**ADDENDUM TO FACT SHEET FOR NPDES PERMIT WA0031682
CITY OF SEATTLE, SEATTLE PUBLIC UTILITIES' COMBINED SEWER SYSTEM**

Modification Date: September 28, 2017

This addendum proposes to modify National Pollutant Discharge Elimination System (NPDES) permit number WA0031682, issued to Seattle Public Utilities (SPU) on March 30, 2016, for its combined sewer system (CSS) and combined sewer overflows (CSO). The Department of Ecology (Ecology) proposes to make the following changes to the post-construction monitoring program requirements outlined in special condition S6.C:

Figure 1. Basin 18 Outfall Location

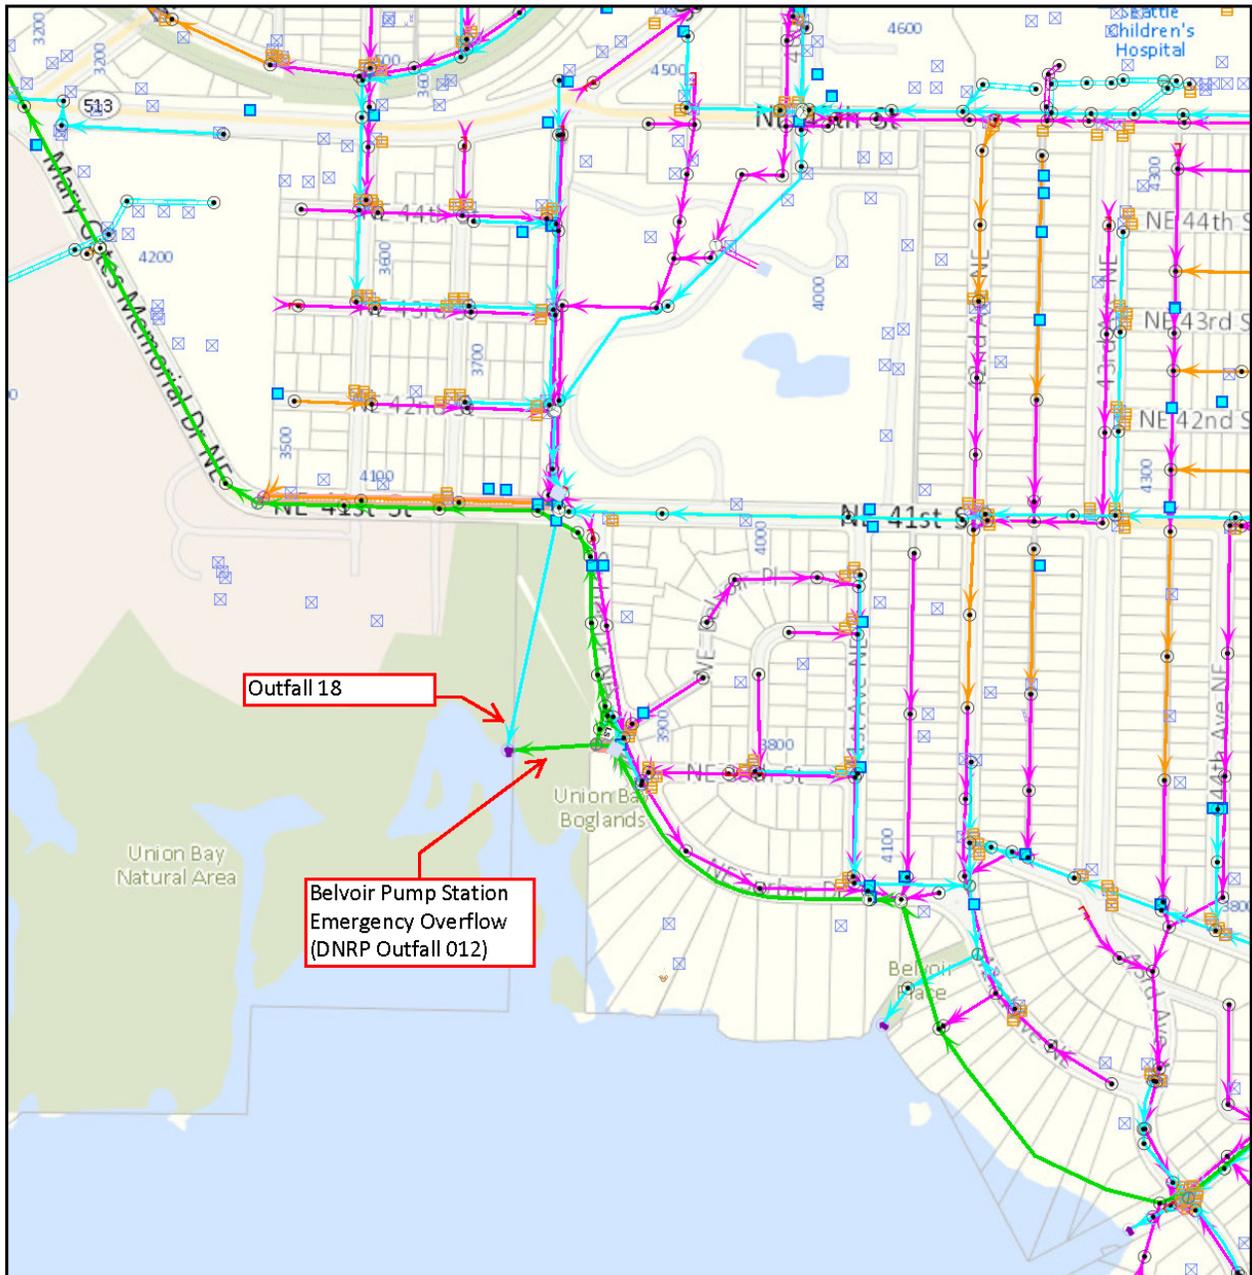
One of the fourteen outfalls was Outfall 18. Basin 18 is in the University District near the Burke-Gilman Trail. Outfall 18 discharges into North Union Bay, immediately adjacent to DNRP's Belvoir Pump Station Emergency Overflow (DNRP Outfall 012). The close proximity of these outfalls is shown in Figure 1.

SPU recently learned that, contrary to the reported status at the time SPU's PCMP and Final PCMP were developed, King County's Belvoir Pump Station Emergency Overflow (King County Outfall 012) is not controlled. Since the intent of the PCMP is to conduct monitoring after an area is controlled, SPU plans to defer the previously scheduled sampling at Outfall 18 until the Belvoir Pump Station is controlled. Specifically, SPU plans to take the following sequential actions:

1. After the Belvoir Pump Station is controlled, SPU will submit an Outfall 18 QAPP/SAP to Ecology and EPA for review and approval,
2. After the QAPP/SAP is approved, SPU will conduct the Outfall 18 post-construction monitoring described in the approved updated QAPP, and
3. Following completion of the monitoring, SPU will submit an Outfall 18 post-construction monitoring report to Ecology and EPA for review and approval.

Remedial Measures – Post Construction Monitoring	Completion Deadline Based on Belvoir Pump Station Achieving Control by December 31, 2031
Submit updated Outfall 18 Draft PCMP QAPP/SAP for review	August 31, 2032
Submit Outfall 18 Final PCMP QAPP/SAP for approval	November 30, 2033
Complete post-construction monitoring at Outfall 18	March 31, 2034
Submit Outfall 18 Draft PCMP report for review	February 28, 2035
Submit Outfall 18 Final PCMP report for approval	April 30, 2036
Submit sediment data to Ecology's EIM database	May 31, 2036

Figure 1. Combined Sewer Basin 68 and CSO Outfall 68.

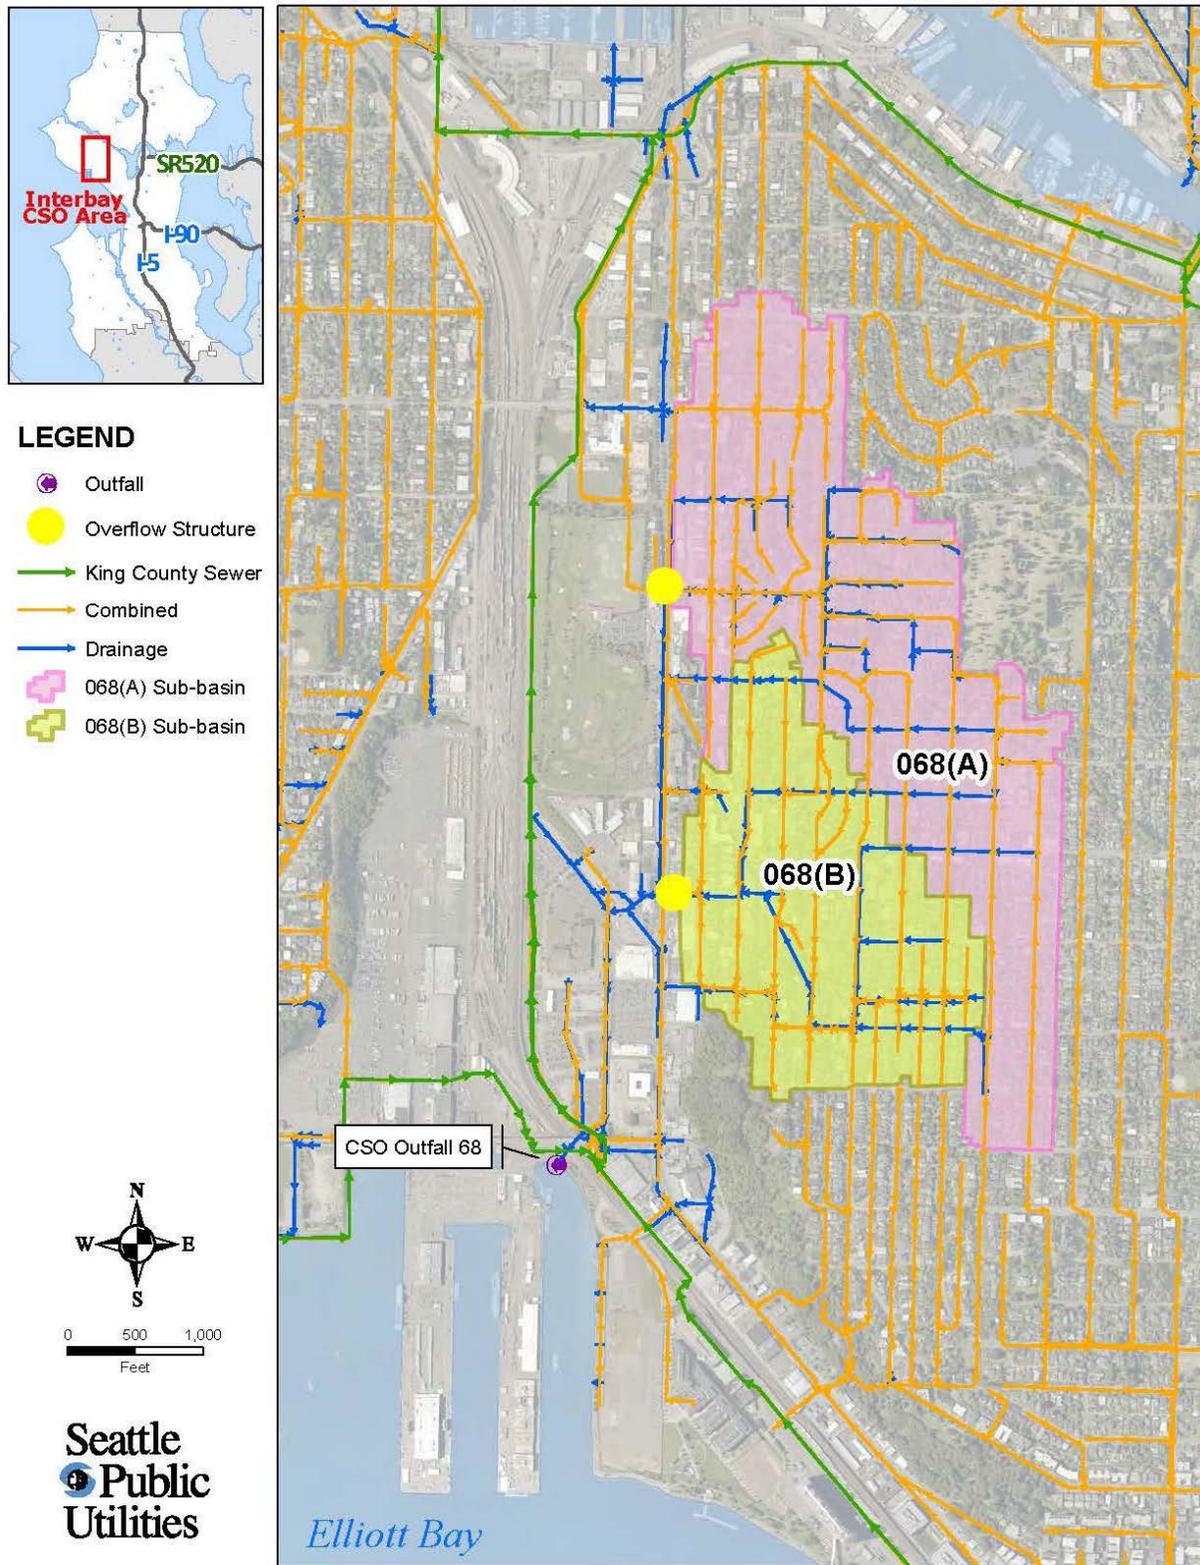
Basin 68 is in Northwest Seattle, on the west side of Queen Anne and to the east of the Interbay railyards. It is a 290-acre (0.45 square mile) basin that consists of two sub-basins: 68A and 68B (see Figure 1). Each sub-basin has a single overflow structure that discharges into a pipe that normally conveys stormwater to CSO Outfall 68. During large precipitation events, when the capacity of the combined sewer system is exceeded, excess flows discharge through these CSO overflow structures into this pipe and through CSO Outfall 68 into Elliott Bay at Smith Cove.

This study area is within the Submerged Lands Area of the Terminal 91 Facility, which is owned by the Port of Seattle (Port) and, unbeknownst to the City of Seattle at the time the Final PCMP was submitted, is the subject of an agreed order between the Port and Ecology for remedial action due to the release or threatened release of hazardous substances (Agreed Order No. DE 8938, April 10, 2012). The First Amendment to the Agreed Order (executed November 24, 2015) requires the Port to develop and implement a Submerged Lands Area Sediment Sampling and Analysis Plan (SAP) and submit a Sampling Report. The results of these sediment sampling and analysis activities will be used to support evaluation of the need for further remedial actions by the Port in the Submerged Lands Area more generally. The First Amendment to the Agreed Order includes a list of activities the Port must complete and a chronological order, but does not provide specific completion dates.

The intent of the Supplemental Compliance Plan is to try to bring the Outfall 68 PCMP and QAPP/SAP compliance schedule into sync with the Port's compliance schedule and in particular with the projected availability of the Port's Final Sampling Report. The Supplemental Compliance Plan schedule is as follows:

Remedial Measures – Post Construction Monitoring	Completion Deadlines
Submit Outfall 68 Draft PCMP QAPP/SAP for Ecology and EPA review. (Final PCMP QAPP/SAP to be submitted following receipt of Ecology and EPA comments.)	Submitted June 30, 2016
Review Port of Seattle's Terminal 91 Final Sampling Report and submit Outfall 68 Draft PCMP report (including SPU field observations and review and analysis of Port sediment data) for Ecology and EPA review. (Final SPU report to be submitted following receipt of Ecology and EPA comments on Draft SPU report.)	Within 180 days following SPU obtaining Port of Seattle Final Sampling Report
